# CITY OF PORTLAND

# BUILDING PERMIT

Job ID: 2012-09-4890-ALTR

has permission to Rebuilding & enlarging front/side decks

ENLARGED PLOT PLAN  
147 LYNN STREET PORTLAND

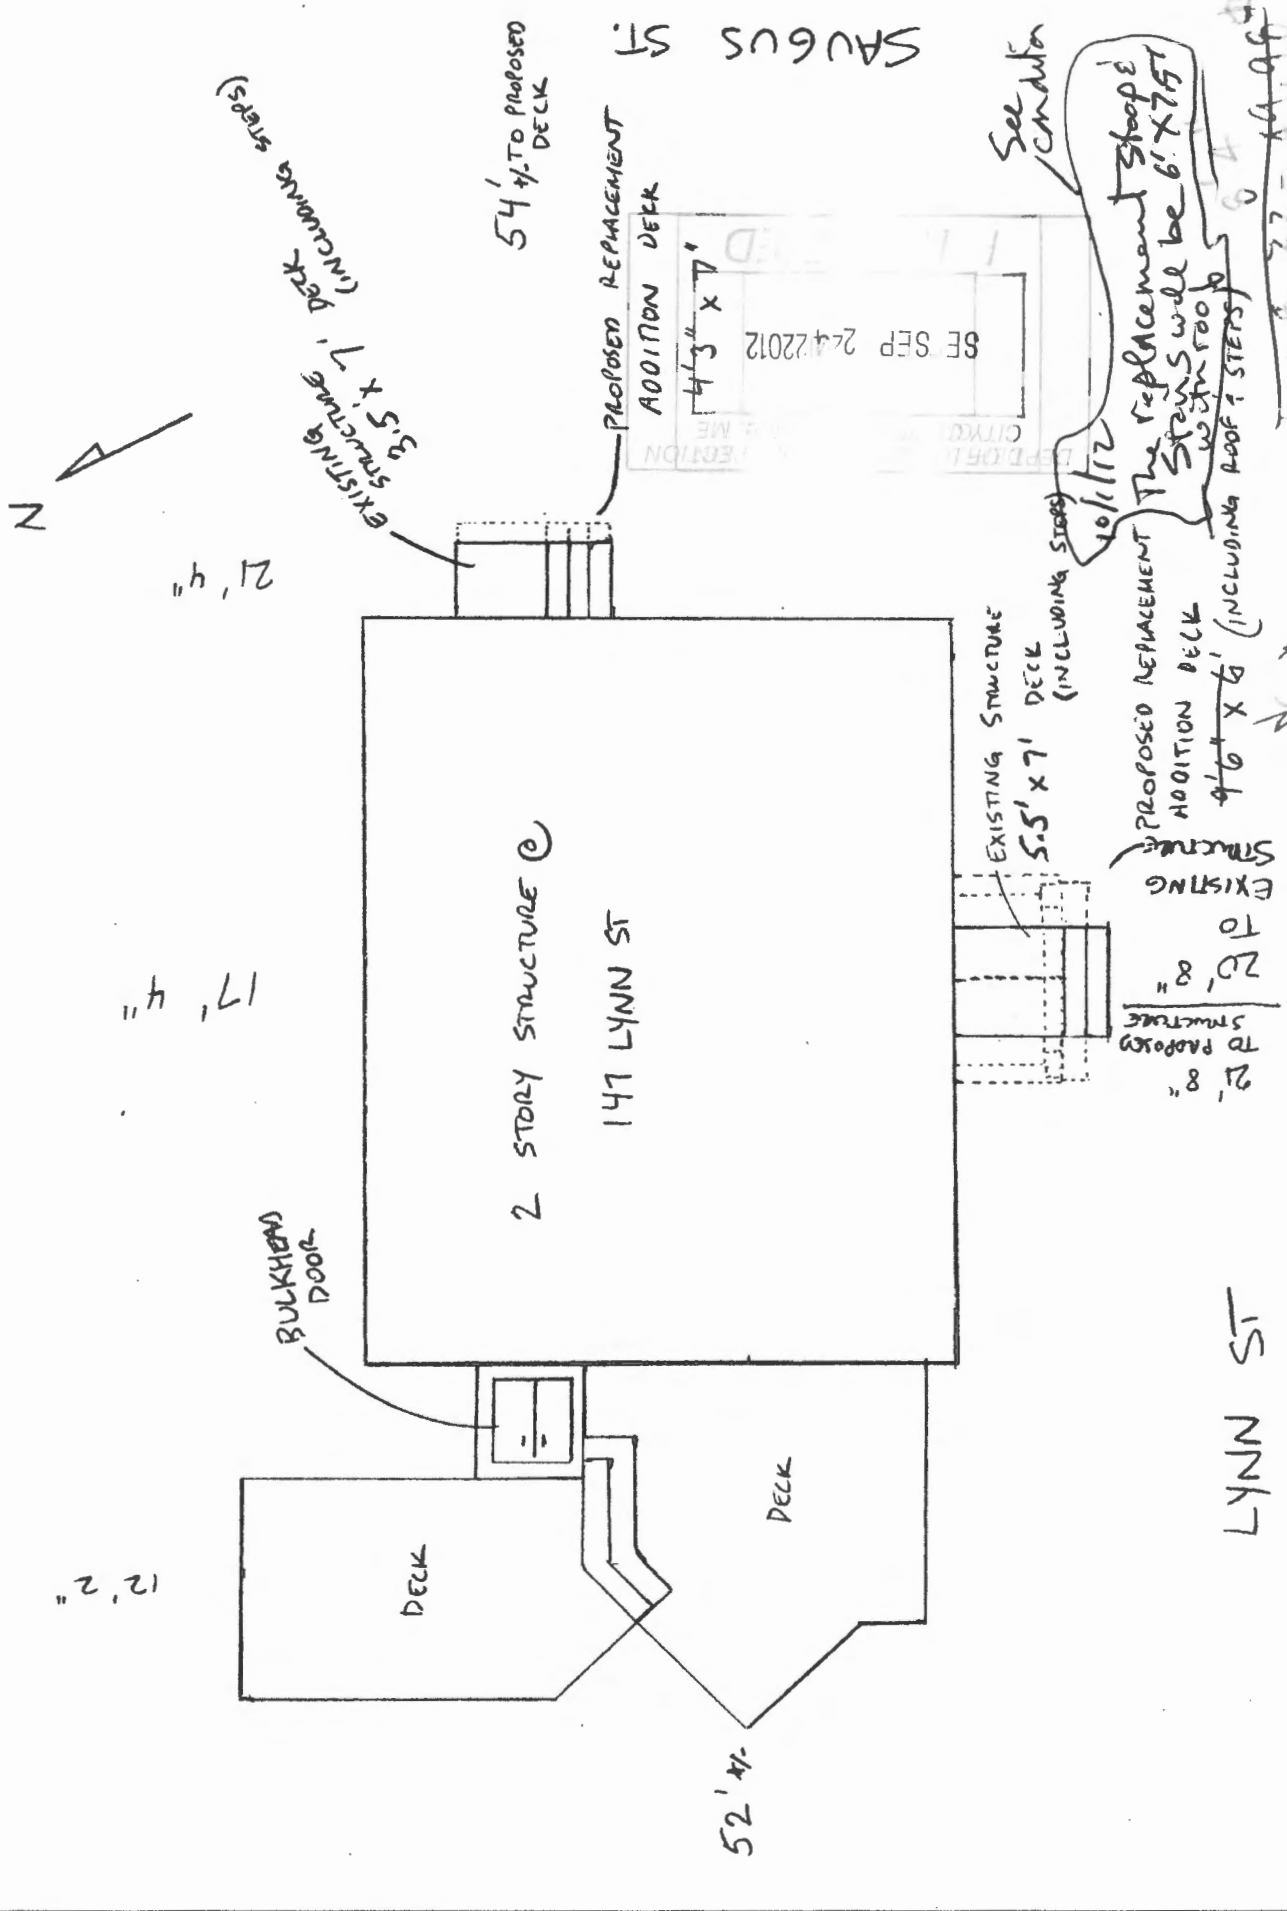
Unfortunately this plot plan does not show the new deck enlargement and set backs from that. Please provide that on the plot plan and send it back.

The issue is this: *what was the original deck size & dimensions* and to show it on the plot plan as "before" and "after". I don't think there was an issue with the shed.

thank you for your revisions. We are not quite there yet. The section of the Ordinance that I was referring to only allows 50 square feet. Your recent submission, 6' x 9.6' = 57 sq. ft. Can you adjust the size to 6' x 8'4"? That would allow you to meet the section of the Ordinance that allows you to build within the required setback of 25'.  
thank you for your efforts on this,  
Marge

The replacement Stoop Stairs will be 6' x 7.5' with roof

REVISED FRONT VIEW FRONT PORCH NE ELEVATION

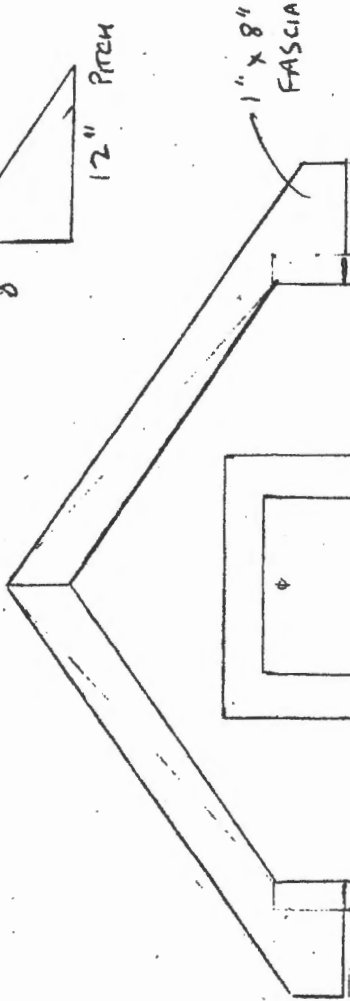
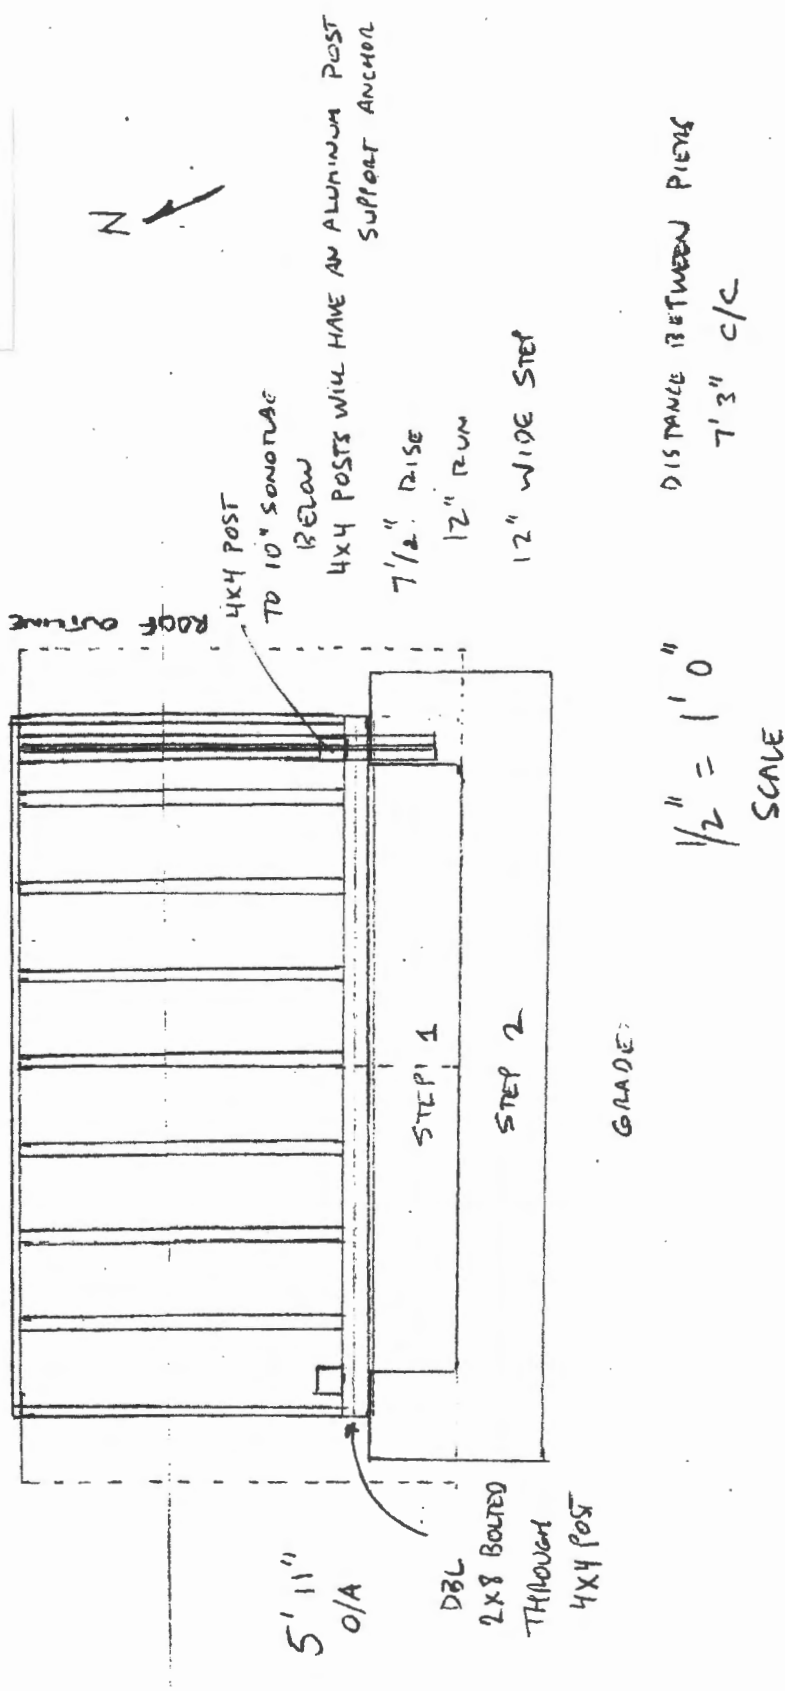
Thank you for getting back to me. When calculating this, does the width of the roof dimension come into play? Because the roof line currently on my drawing is 9.5' but I assumed that because it's above, it doesn't apply as square footage.

2. It is understood that the rebuild of the front entry will result in the front stoop and stairs to project no more than 6' from the front of the building. The width of the front stoop and stairs shall be no wider than 7.5' as given. The roof may overhang several inches as proposed.

ENLARGED PLOT PLAN  
147 LYNN STREET PORTLAND

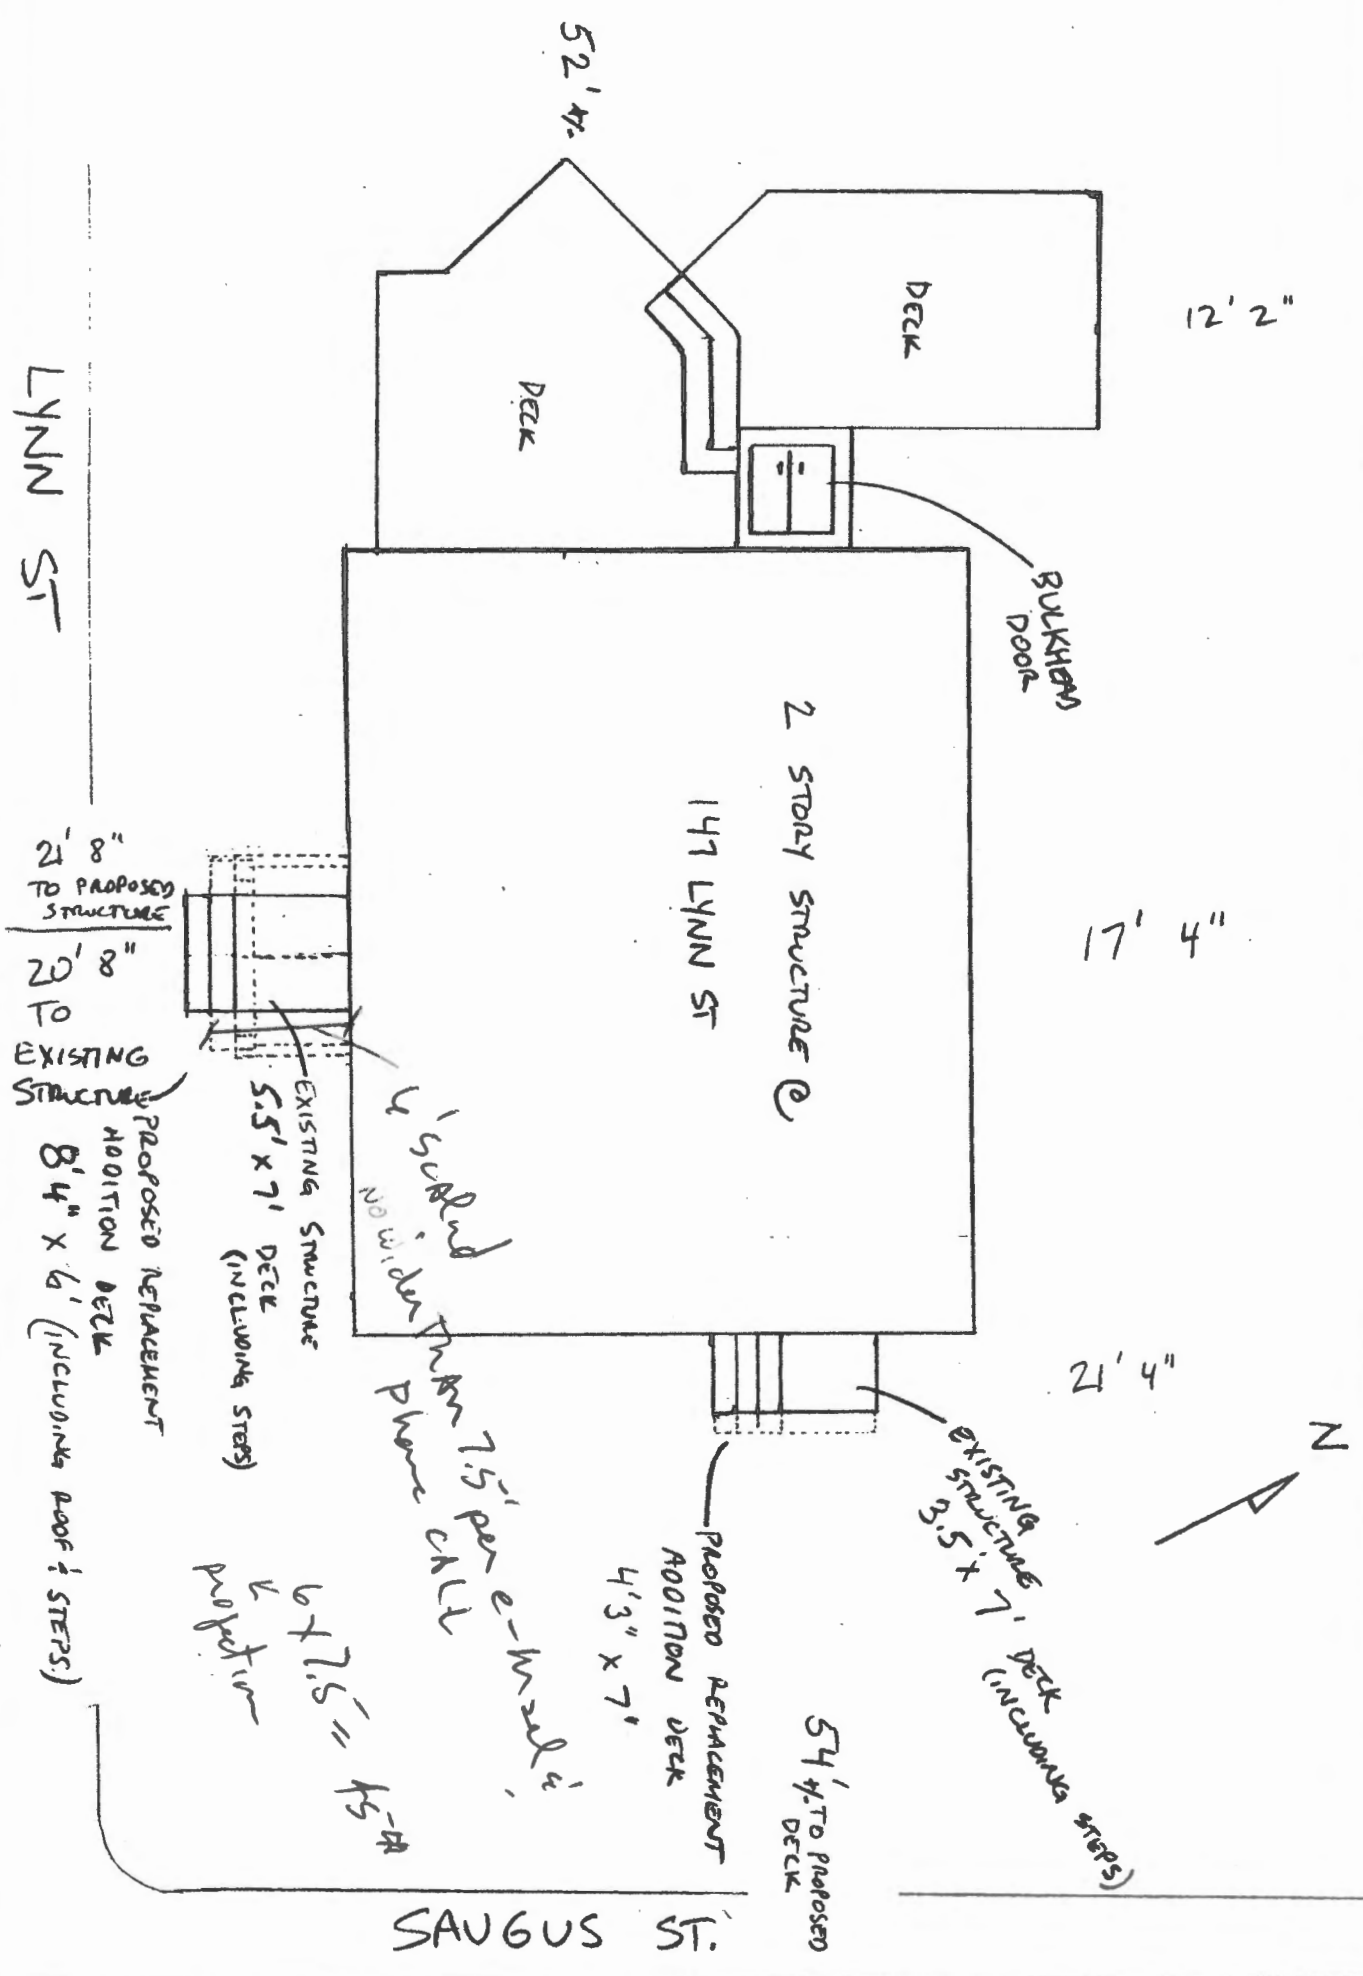
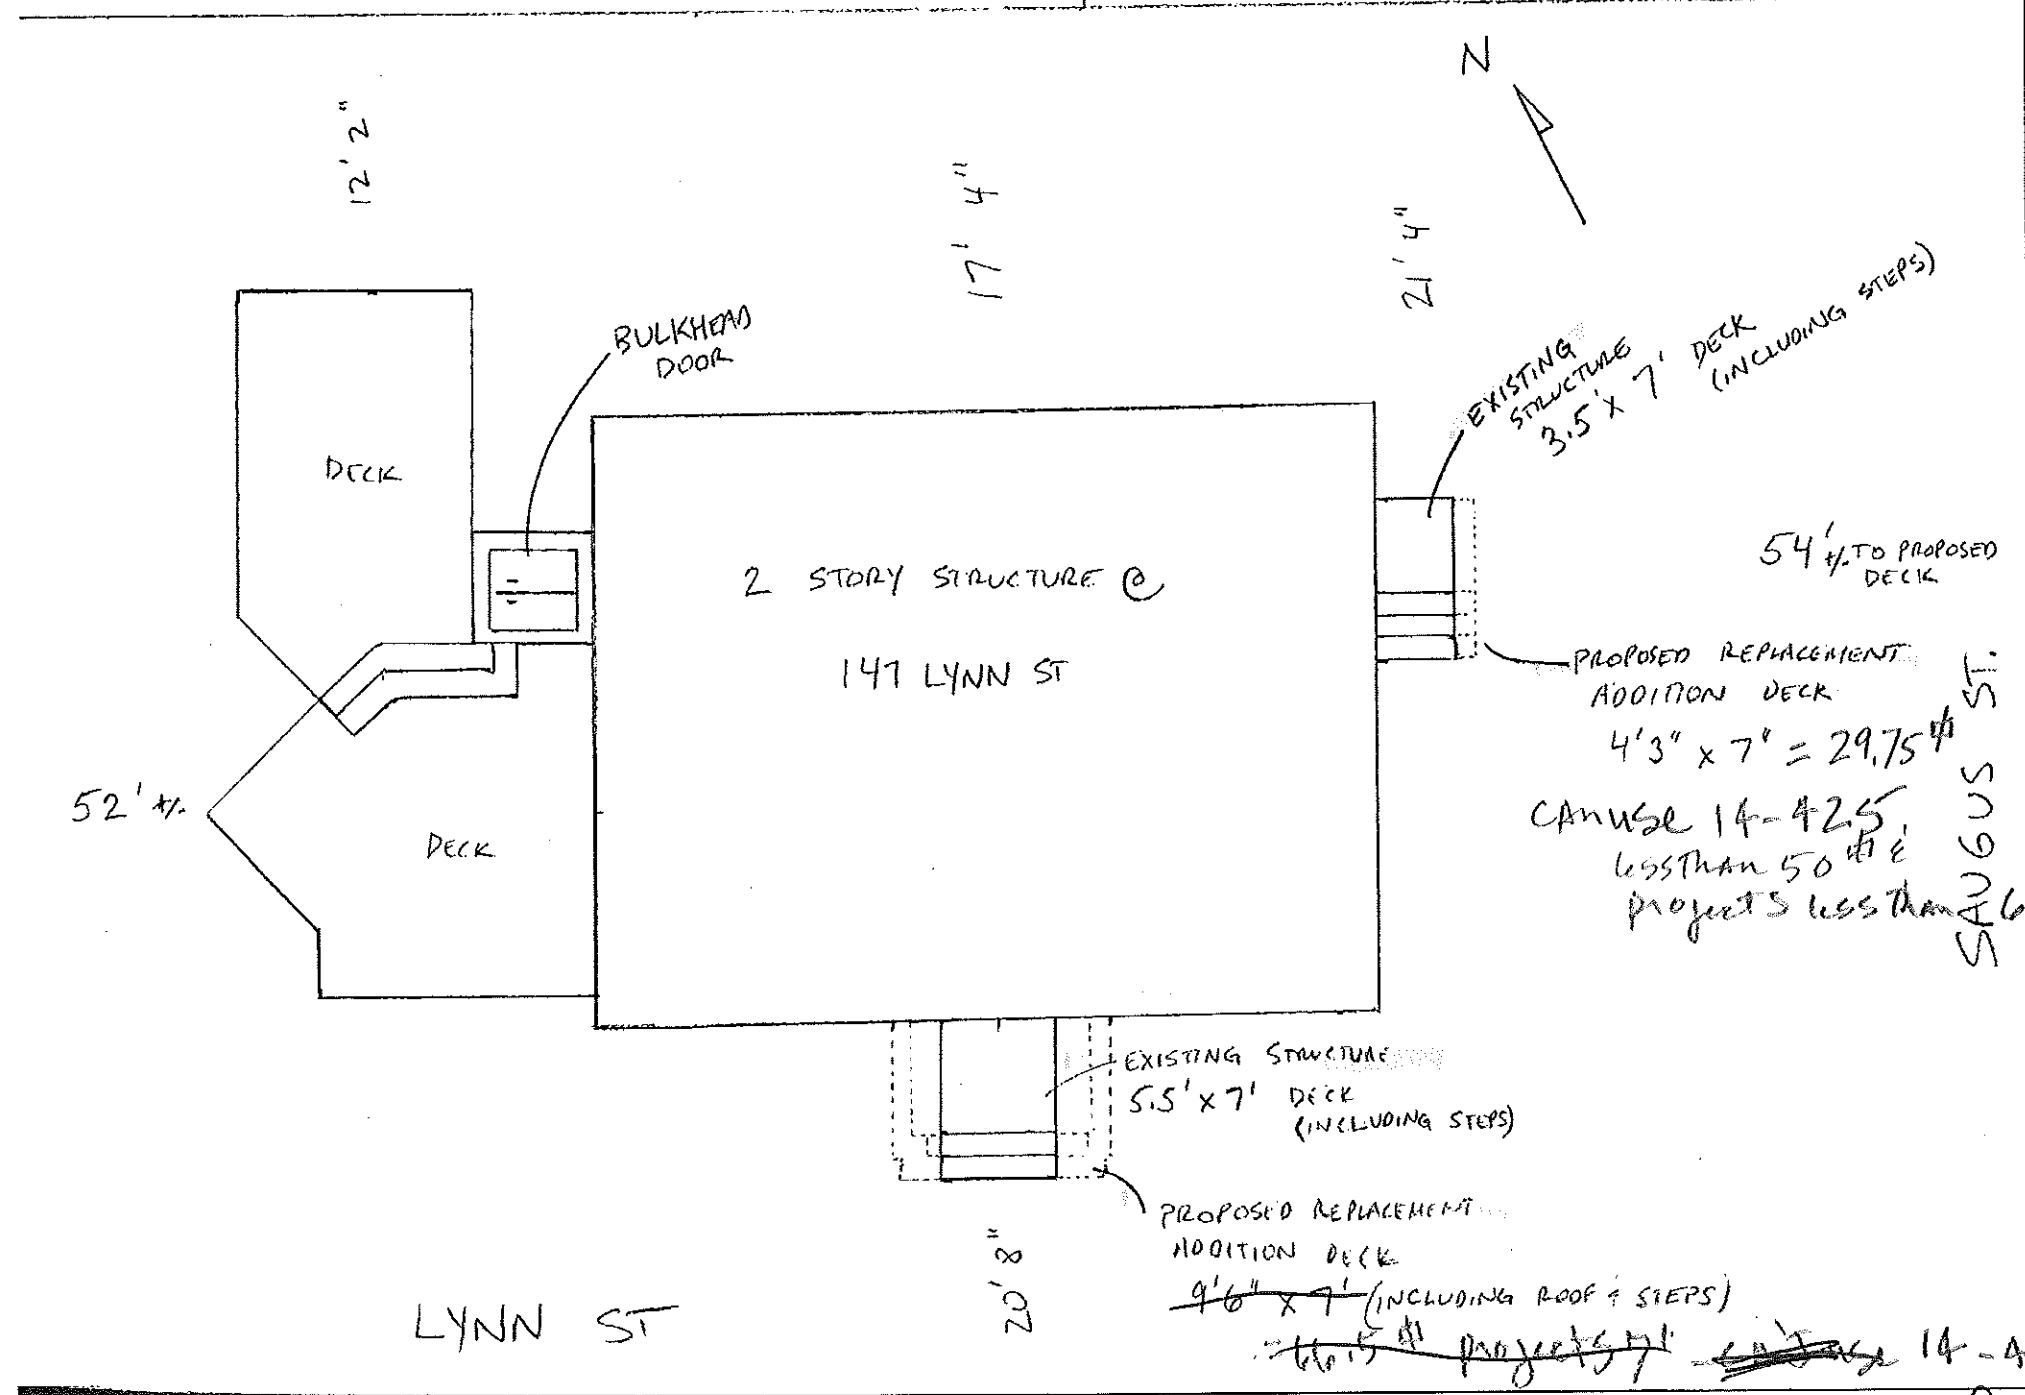
PROPOSED REPLACEMENT ADDITION DECK  
4'3" x 7" = 29.75 sq ft  
CAN USE 14-425'  
LESS THAN 50 sq ft  
PROJECTS LESS THAN 26'

~~14-425'~~ ~~PROJECTS~~

see PERMITS - see e-mail w/ photo  
Stoop & stairs to be no more than 6' projection from the house  
17.58' x 7' = 45 sq ft

# MOST CURRENT PLAN

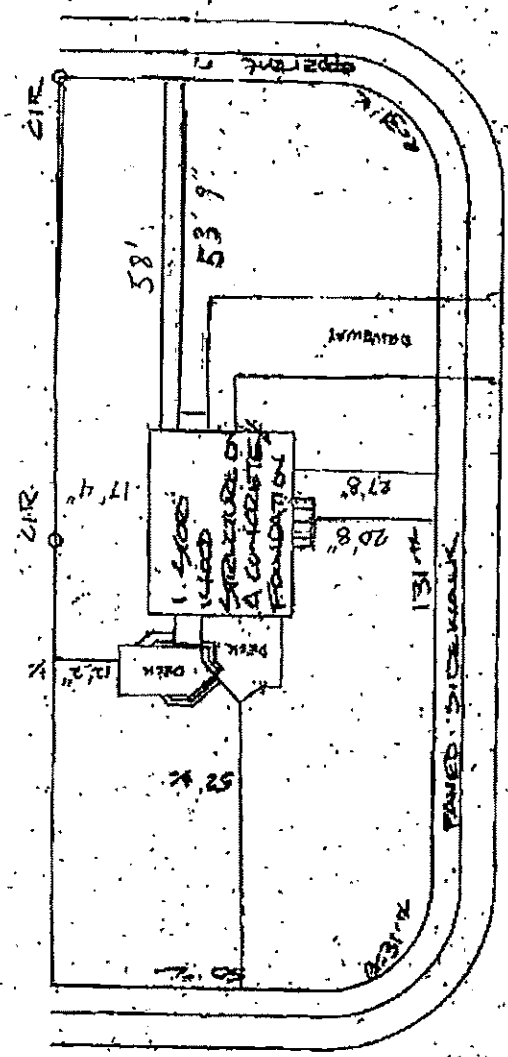
Typically, permits like this need a current plot plan (no changes) and a proposed (with changes) with measurements on all sides of all structures. They can be on the same plot plan, but need to be differentiated in some way. (Typically proposed changes are highlighted or changed from the original in some way.) Are you saying the proposed changes are part of the plot plan you provided?

The plot plan includes both the front deck enlargement (width only) as well as the side porch enlargement. I've included the correct setback on the side porch and there is no change on the setback for the front porch.

If you look at the right side, the setback is 53' 9" from the enlarged side porch to the sidewalk. The front porch remains unchanged at 20' 8"
